MARTIN COUNTY, FLORIDA DEVELOPMENT REVIEW

STAFF REPORT

BARON LANDINGS PLAT

Report Number: 2024 0906 G076-011 Staff Report Final

SHEET 1 OF 6

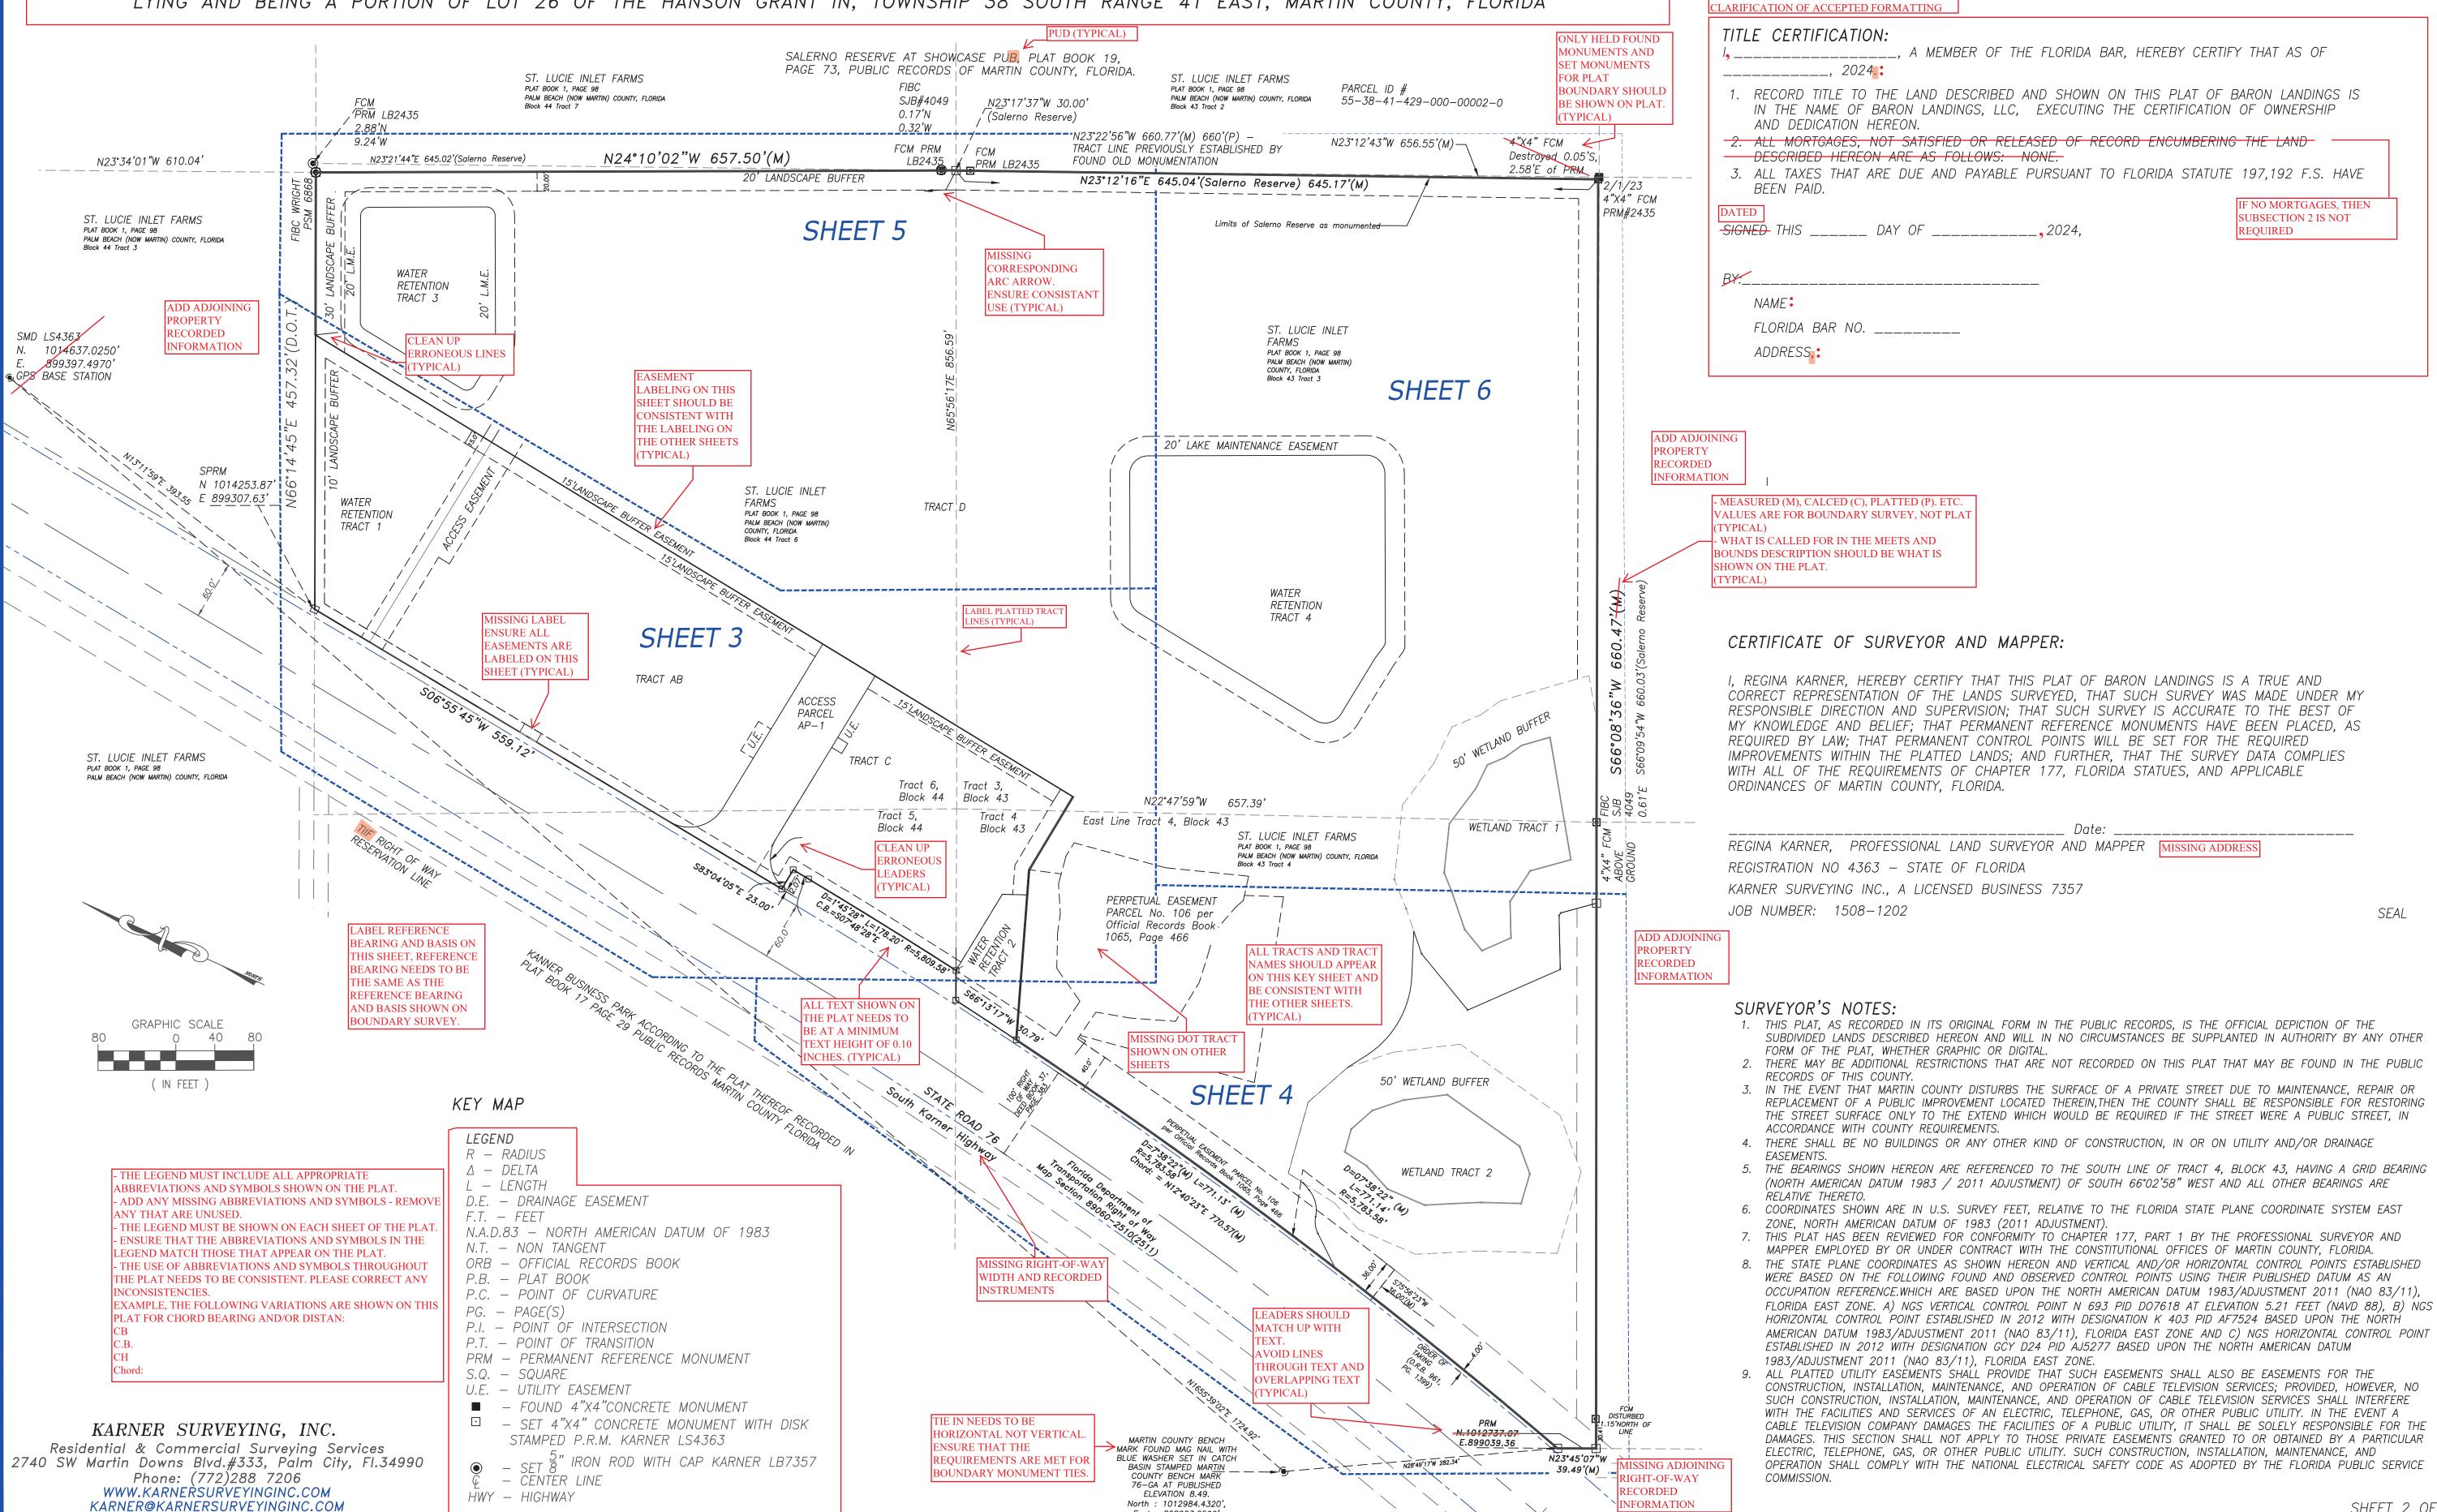
LOCATION MAP (NOT TO SCALE)

ENSURE ALL BEARINGS

CORRECT MISSPELLINGS

TRACTS 3 AND 4, BLOCK 43 AND TRACTS 5 AND 6, BLOCK 44, ST. LUCIE INLET FARMS SUBDIVISION, ACCORDING TO THE PLAT THEREOF RECORDED IN PLAT BOOK 1, PAGE 98, PUBLIC RECORDS OF PALM BEACH (NOW MARTIN) COUNTY, FLORIDA, LYING EAST OF STATE ROAD 76 AND-NORTH AND WEST OF SALERNO RESERVE AT SHOWCASE PUD, AS RECORDED IN PLAT BOOK 19, PAGE 73, PUBLIC RECORDS OF MARTIN COUNTY, FLORIDA MORE PARTICULARLY DESCRIBED AS FOLLOWS:

ADD: AND NORTH OF SALERNO RESERVE AT SHOWCASE PUD PHASE 2, PB 20 PG 3 BEGIN AT THE POINT OF INTERSECTION OF THE NORTH LINE OF SAID TRACT 6, BLOCK 44, ST. LUCIE INLET FARMS, WITH THE EASTERLY

SURVEYOR'S NOTES: MAKE REVISIONS TO THE SURVEYOR'S NOTES SHOWN ON EACH SHEET

ON EACH SHEET MUST BE CONSISTANT

THIS ONLY NEEDS TO APPEAR ON SHEET 1

2740 SW Martin Downs Blvd.#333, Palm City, Fl.34990
Phone: (772)288 7206
WWW.KARNERSURVEYINGINC.COM
KARNER@KARNERSURVEYINGINC.COM SHEET 3 OF 6

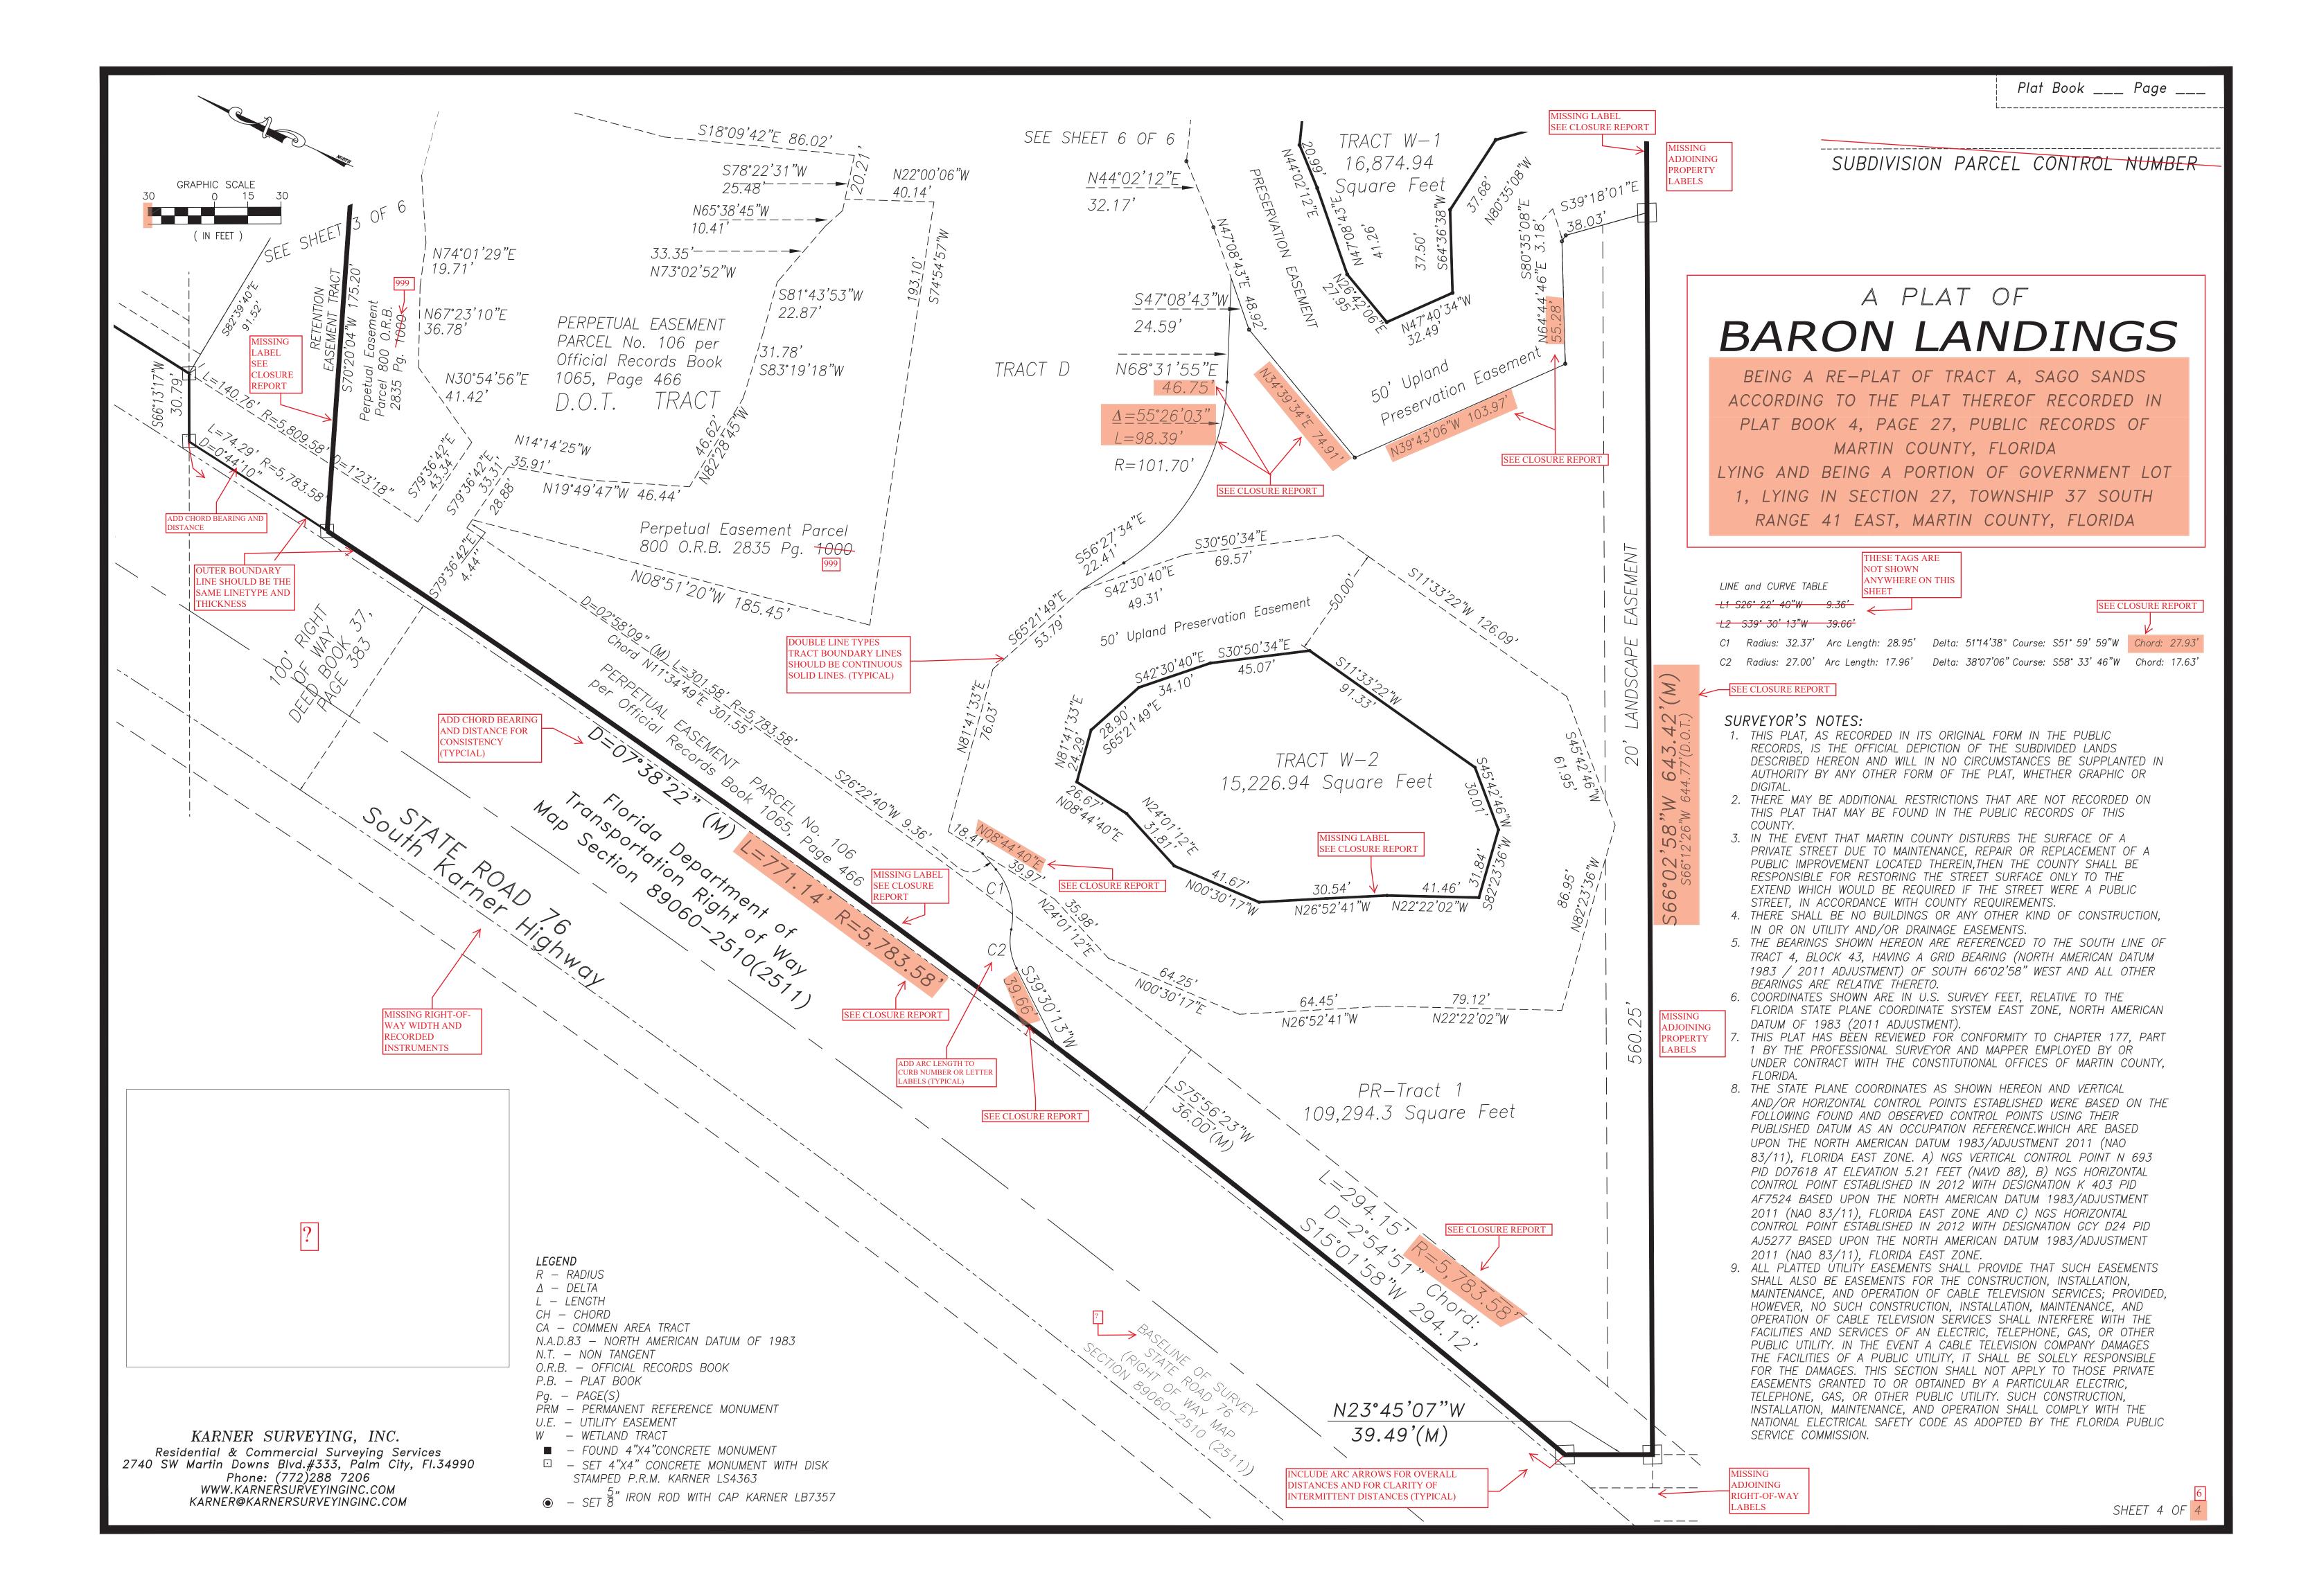
- #1 Please add the label S Kanner Hwy to plat page 3 of 6.
- #2 Please add the label SE Baron Way to the Access Parcel A-1 on plat page 2 of 6 and 3 of 6.
- O. Determination of compliance with utilities requirements Utilities Department
